Opposition to high density condo towers at 3056 Neyagawa Blvd.

2025-03-17

Application doesn't match to Traffic Impact Study

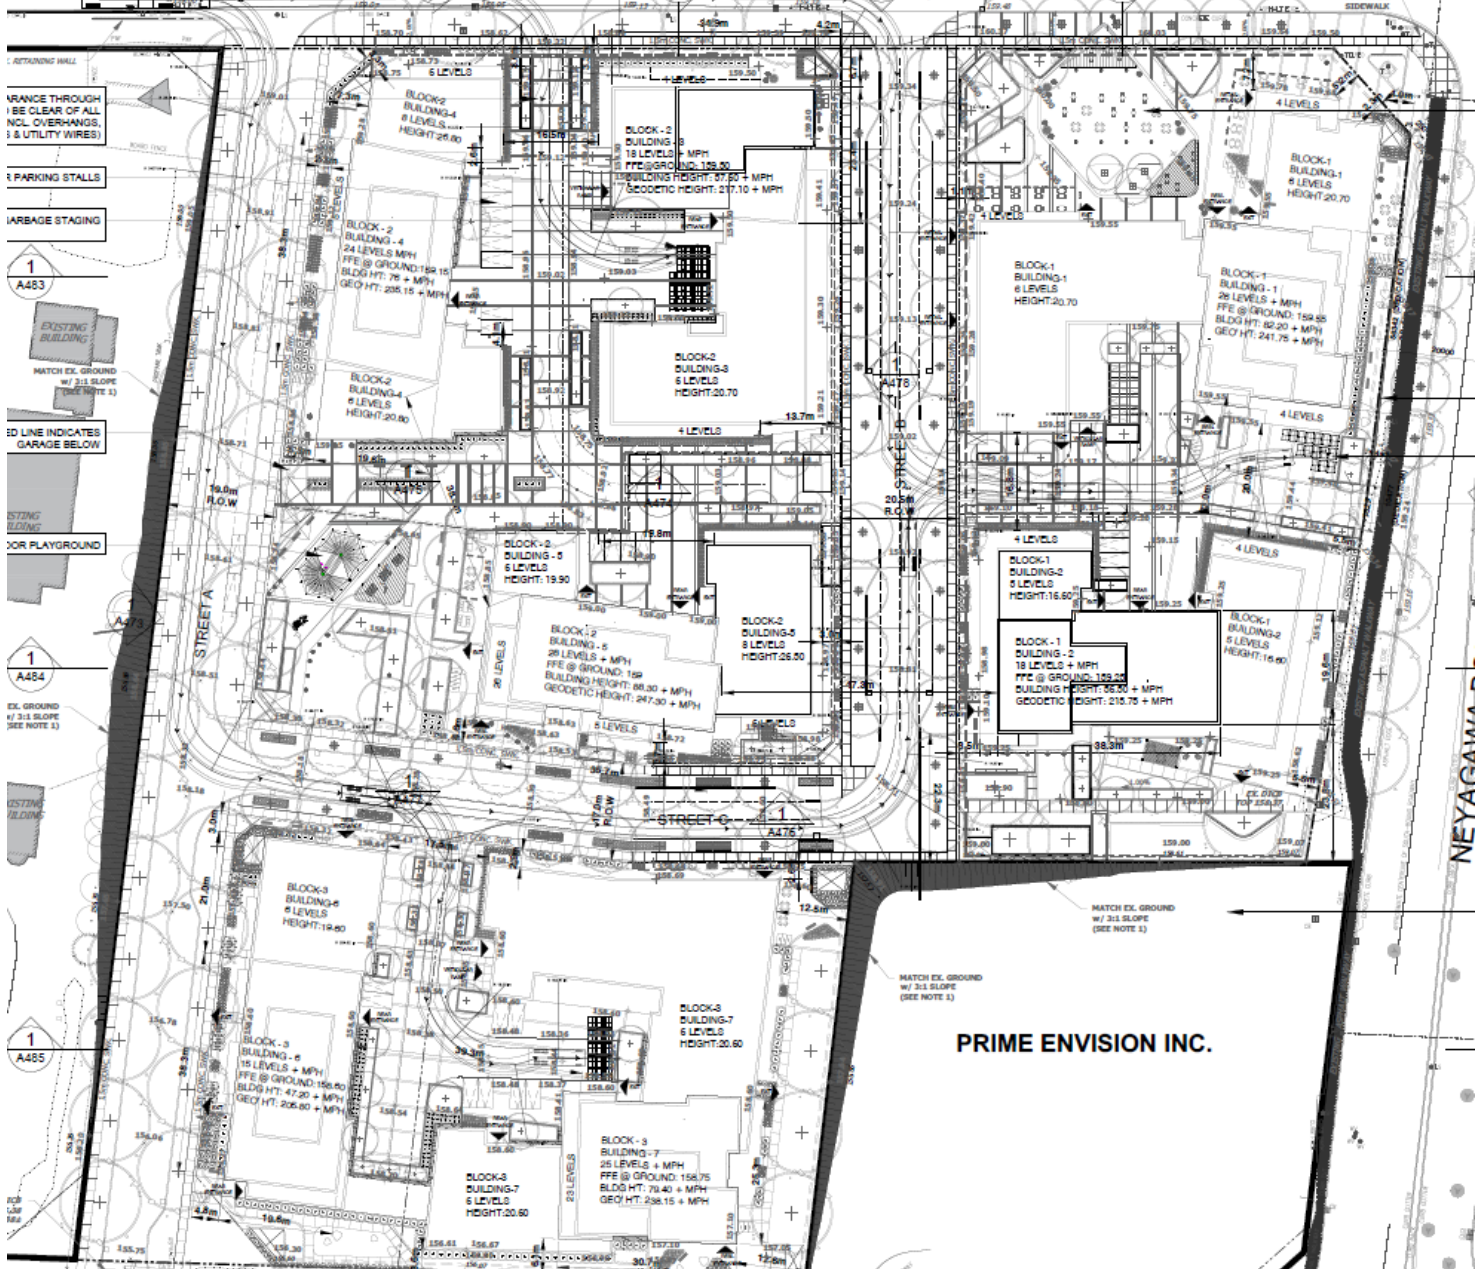
There are only 29 surface parking spaces for this mega project of 2,278 residential units + 1,550 sqm retails, including those along the streets. This will leave visitors and retail customers scramble around to find parking, which exacerbates traffic congestion within the community and surrounding area.
